CCO #EC-001

Project: AS7.001.001 - Ogdensburg CSD Capital Improvement Project  
1100 State Street  
Ogdensburg, New York 13669

## Change Order Authorization #EC-001: CE #027 - RFI #Ph1-29: Electrical Primary Duct Bank

Figure 20.0-1 Typical Trenches

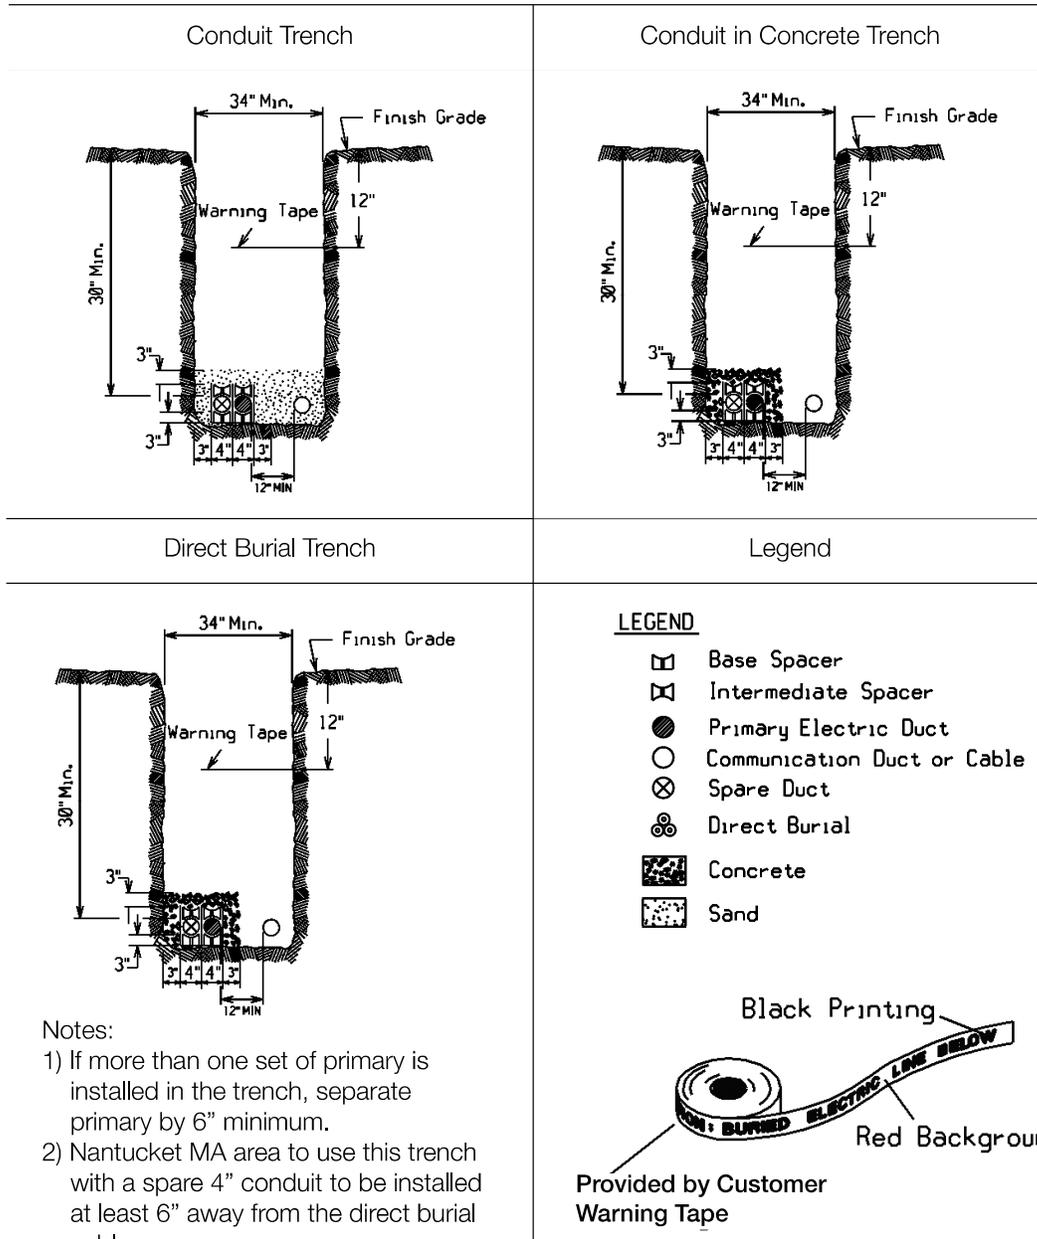
CE #027 - RFI #Ph1-29: Electrical Primary Duct Bank: Per RFI #Ph1-29 (see below), the below grade primary electrical feed from the utility pole to the pad-mounted transformer is required by National Grid standards (see attached) to be in Schedule 80 PVC conduit encased in a concrete duct bank. The contract drawings call for rigid conduit with sand bedding under the parking lot and Schedule 80 PVC under grassy areas. No concrete encasement is called out. ***RFI #Ph1-29: Electrical Primary Duct Bank Question (Collins-Hammond Electrical Contractors, Inc.): After speaking with National Grid, we are required to provide schedule 80 PVC conduit with concrete encased from National Grid Pole to Pad mounted transformer. EL100 calls for 4" GRC with sand bedding for under parking lot and schedule 80 under grassy areas. Please confirm the change and add for concrete encased. Response (BCA Architects & Engineers): Please provide concrete encasement per National Grid's Requirements. Submit the detail intended for clarification. Follow up response 10/7/25: place below grade primary as required by National Grid standards.	\$20,079.38

## 20.1 Trench Depth New York/New England Concrete Encased Conduit

Burial depths for electrical conduit shall be maintained not less than 30" from the top of the concrete encasement to grade during all phases of construction. The trench bottom shall be solid, undisturbed earth. Earth showing signs of peat, cinders, rubble, or any conditions not suitable for a stable foundation shall be reported to the *Company* for recommendation. Small pockets of unsuitable soil shall be replaced with compacted gravel (max. 2" stone). At riser pole end concrete encasement just before riser sweep.

**1 ELECTRICAL SITE PLAN**  
SCALE: 1/8\"/>

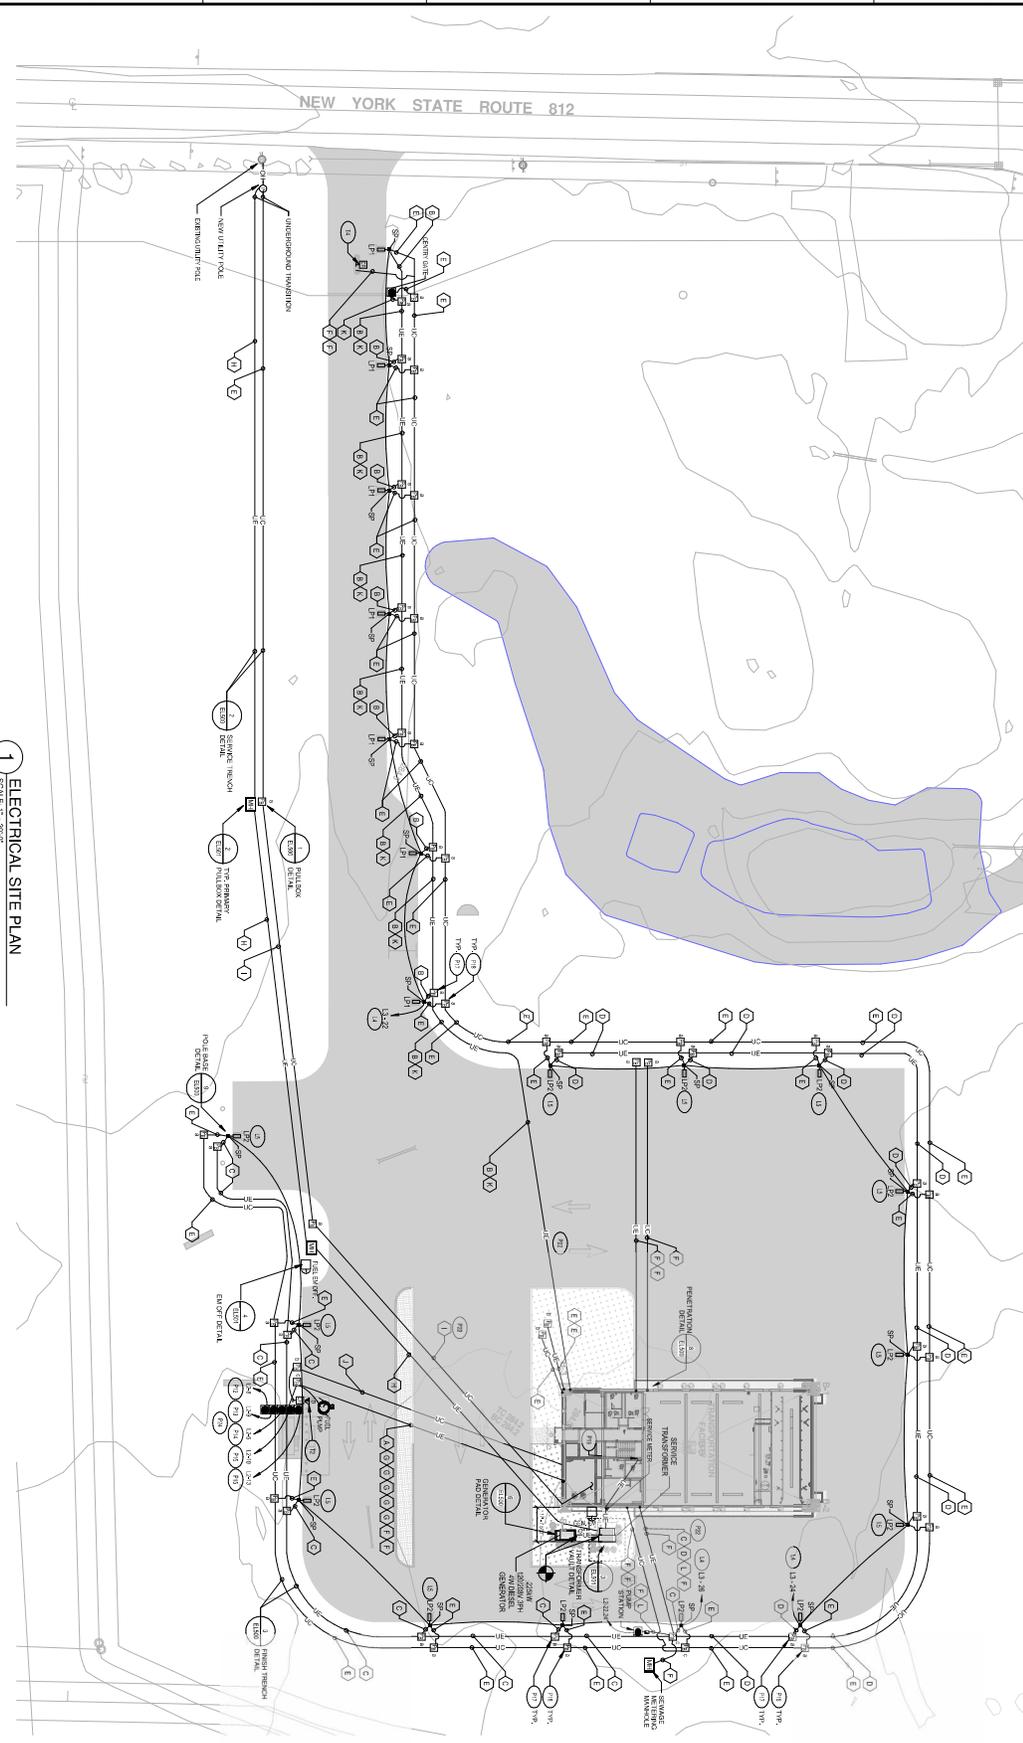
A.	National Grid
B.	Under the Capital Project, a new underground primary electrical feed was being routed from an existing utility pole on New York State Route 812 to a pad mounted transformer adjacent to the new transportation facility as per Contract Drawing EL100.

C.	During construction, the Electrical Contractor had to coordinate and comply with the power utility (National Grid) requirements for the installation of the new electrical primary feed. Rather than install the cabling & related 4-inch conduits in a sand bed trench, National Grid requested that all conduits be encased in a concrete duct bank for its entirety from the utility pole to the transformer. As such, the Electrical Contractor provided the concrete encasement in accordance with the National Grid standards.

D.	Add for all labor, materials & equipment to provide a concrete encased duct bank for the primary electrical feed from the existing utility pole on New York State Route 812 to the pad mounted transformer adjacent to the new transportation facility.
